RE: Order SWD-917 Spumoni SWD

OXY SPUMANTI STATE

**** CHART SCANNER WELL TEST DATA ****

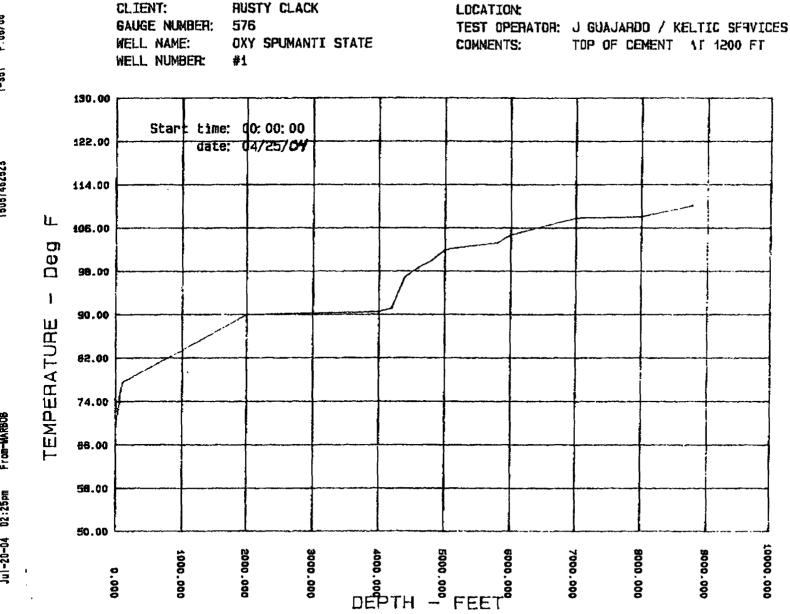
The captioned order says we need to run a cement bond log to verify cement top. We ran a temperature survey after pumping cement to determine the top of cement. Can we skip the CBL since we have a temp survey that verifies that the TOC has overlapped the intermediate casing (1000' of overlap)? Thanks.

J GUAJARDO / KELTIC SERVICES TOP OF CEMENT AT 4200 FT DATE: 04/25/04

In this case, since the overlap is so much, sounds fine to scrap the bond log for cement verification purposes,unless you need the information it gives to look for permeable zones in the well...
